EGRESS WINDOW CRANK HANDLE

Bulletin Type:	Safety Recall
Bulletin #:	19V-691 US 2019-501 Canada
Job Code:	9901441
Flat Rate:	.3 hour

Publication Date:	October 2019
Make:	JAYCO
Model:	Jay Feather HY
Model Year:	2019-2020

FIG 1:

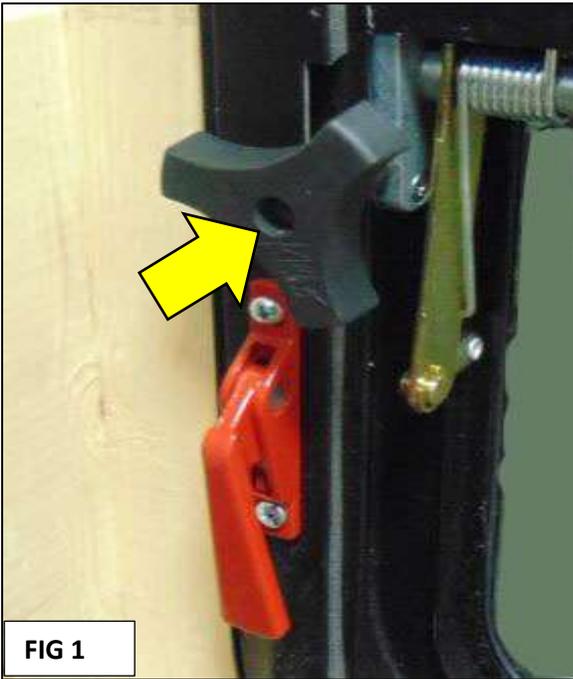
Incident:	Crank handle on emergency window prevents opening to the extent required for an egress.
Affected Units:	2019 Jay Feather HY K1JH0185-0274 2020 Jay Feather HY L1JH0051-0080
Parts Kit:	Parts Kit #: 19V-691
	Red Z shaped handle
Misc. Tools & Supplies:	Screw gun with long #2 Philips bit

- Remove the philips screw in the black knob on the egress window
Save screw to install new handle – remove knob and discard.

- Place the red Z shaped crank handle on the stud – use screw removed from original handle.
- Tighten the screw on the new crank handle .
